Ref No: 050/2023/PMID/SHUTDOWN/RFB

TENDER CLARIFICATION NO.1:- FOR APPOINTMENT OF CONTRACTOR SERVICES TO PROVIDE LHWP 2024 SHUTDOWN OUTAGE – INSPECTION AND REPAIRS OF DELIVERY TUNNEL NORTH (DTN) AND EROSION PROTECTION TO ASH RIVER - (6 MONTH SHUTDOWN)

Figure 2-1: Critical river reaches investigated in this study

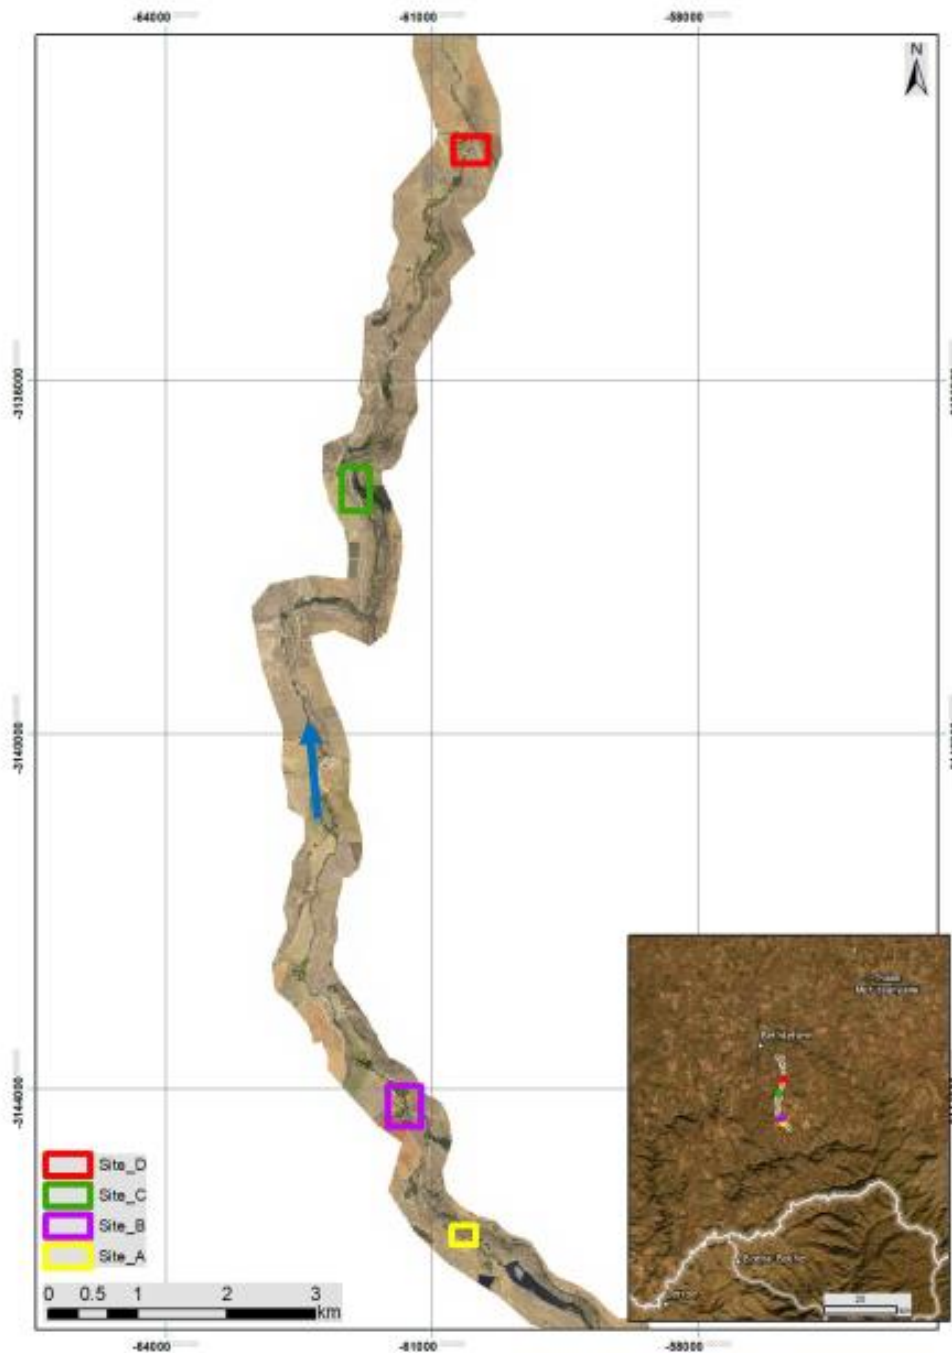
7	<u>9.2.6 Stormwater Canals</u> There is 1500m3 excavation and 3000m3 of Berm. Please can you indicate where over the 21km outfall river section this is? and is the excavation just soft excavation and no shaping?	1500 m3 is excavation from riverbank to shape the river bank and 3000 m3 is cut to fill to create and shape the berm. See Section C2 berm for location
8	<u>9.1.2</u> If the boulders are very large can they be made smaller with Chemical Explosives? and what is the size they can be reduced to?	The use of chemical explosives is allowed however the contractor must comply to explosives regulations as in the OHSACT. Size can be reduced until it is small enough to move.
9	<u>8.5 Cleaning of Algae and Debris Sum.</u> For Bidding Purposes please can we have something to Price on M2 of Algae and m3 of Debris?	50m2 of algae needs cleaning and 2m3 of debris to be removed

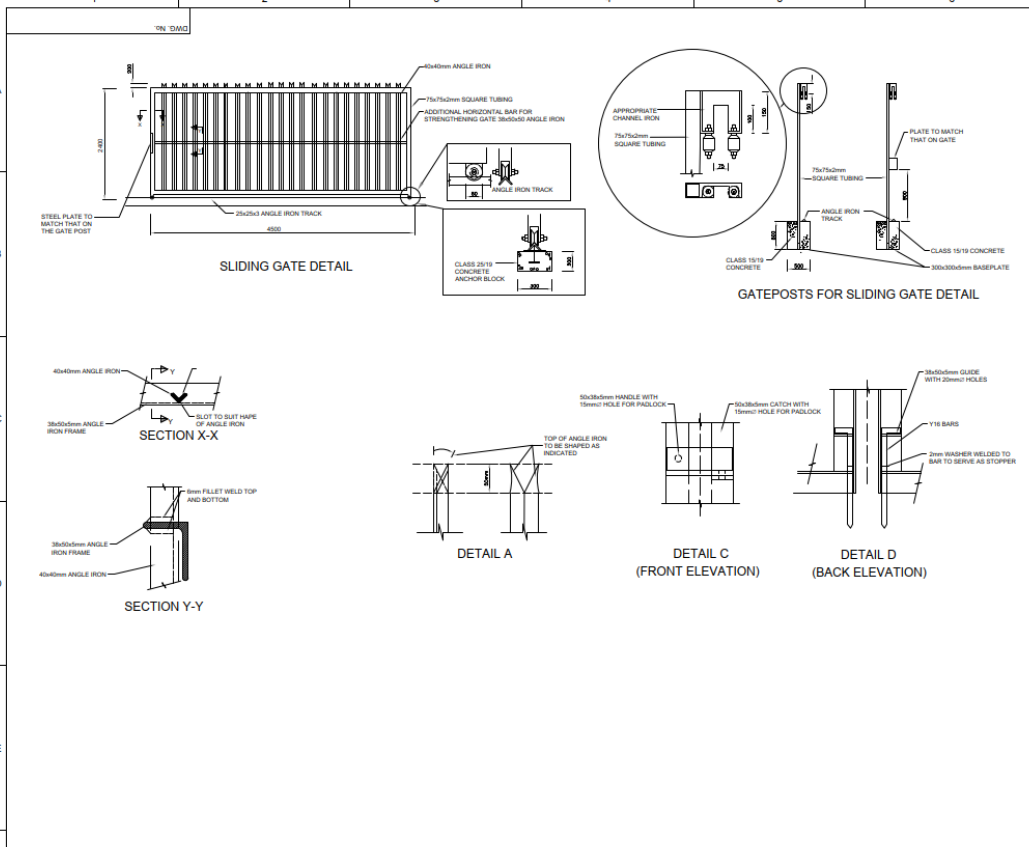
NO.	REQUESTS FOR CLARIFICATION	TCTA RESPONSES
10	<p><u>6.1.3</u> Please can you clarify what is a Shakuma wall and if alternatives are possible?</p>	<p>Alternatives are possible, see attached drawing for Shukuma walls.</p>  <p>The drawing consists of several parts: <ul style="list-style-type: none"> SHUKUMA COLUMN BASES: Scale 1:10, showing top and side views of the base. SHUKUMA WALL PLAN: Scale 1:10, showing the layout of the walls with dimensions. SHUKUMA COLUMNS: Scale 1:10, showing a side view of the column. SHUKUMA WALL SECTION: Scale 1:10, showing a cross-section of the wall with internal structure. SECTION B: A detailed section of the wall base. GENERAL NOTES: A list of 10 notes providing specific instructions and material requirements. </p>
11	<p><u>6.1.4</u> Please can we have a shop Drawing of the Supply and install Gate or a Photo?</p>	<p>See attached drawing H371936-000-220-260-0001-0001 Rev0</p>

DRG No. Hn 417-95

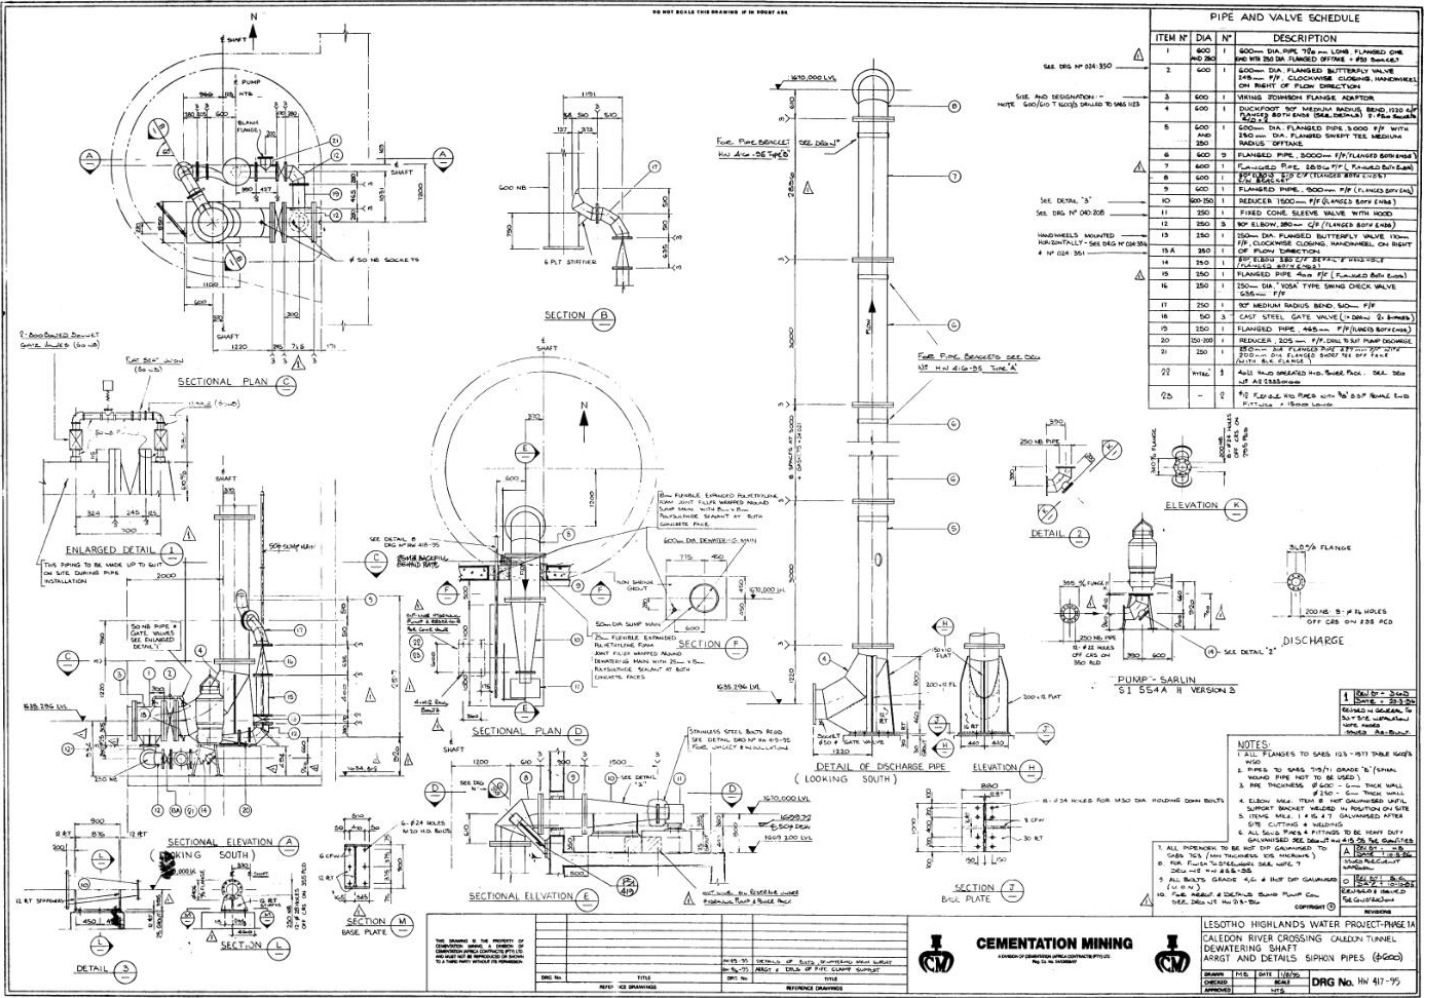
12	<p><u>5.8</u> Camera required for internal inspection. Please indicate where we will get entry?</p>	<p>Caledon Dewatering Shaft - see drawing hw417-95 remove item number 8 top elbow. Little Caledon Dewatering Shaft – see drawing C38-1218 item number 9 top elbow.</p>
13	<p><u>5.8.2</u> Expose valves for Inspection. Does this mean strip Valve into its components? Please can we have Valve Manufacturers to see if they still have spares as many Rand Water Valves no longer have stock of spares.</p>	<p>No stripping the valve will be in step 2 which will only be done if required. OEM (AVK Group)</p>
14	<p><u>5.8.4</u> How are the sacrificial anodes attached to the Valve Blade?</p>	<p>bolted</p>
15	<p><u>5.8.7</u> To what pressure must the Valve be tested?</p>	<p>200KPA for 2 minutes</p>
16	<p><u>5.717 & 5.8.16</u> Inspect and report on 50mm Bonnet Gate Valves and piping Smith class 800. Payment is 1 Sum. How many Valves and how many metre of Piping?</p>	<p>See drawing hw417-95</p>
